FINAL ENVIRONMENTAL IMPACT REPORT  
**FOR THE HERCULES INTERMODAL TRANSIT CENTER**

STATE CLEARINGHOUSE #2009112087

## **Final Environmental Impact Report**

Figure 2.2-3. Culvert Crossing for North Channel at John Muir Parkway

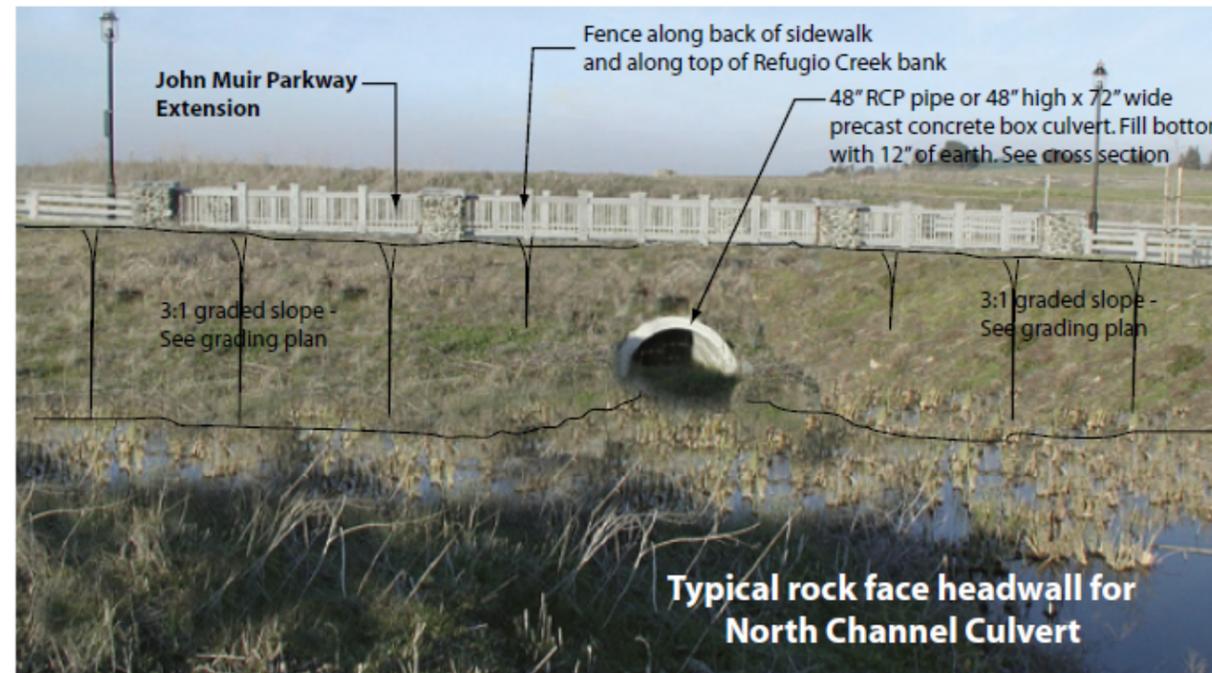
On page 2-11, Figure 2.2-3 Culvert Crossing for North Channel at John Muir Parkway has been replaced, as shown on the following page.

The John Muir Parkway crossing at the North Channel was designed to accommodate a 100-year storm event that would include the run-off from the adjacent business park, adjacent streets, and the planned flow from the Bayfront Development. The proposed crossing type was evaluated in consideration of technical constraints, functional requirements, and cost, and to mitigate environmental concerns.

A clear span bridge was considered as an alternative to cross the North Channel. However, due to the soft soils present on the site and utility constraints, construction of a bridge or an open bottom culvert would require an elaborate foundation system and significantly higher costs to address the low flows anticipated in the intermittent drainage, and thus standard culvert construction is considered more practicable. The culvert has been designed to allow the plan and profile of the fresh water intermittent drainage to continue unencumbered under John Muir Parkway and sized to accommodate both the minimum hydraulic requirement and a 100-year flood event. The culvert crossing was initially sized as a forty-eight (48) inch reinforced concrete pipe (RCP) (or alternatively a 4-ft box culvert) with an earth bottom to satisfy the calculated hydraulic conveyance.
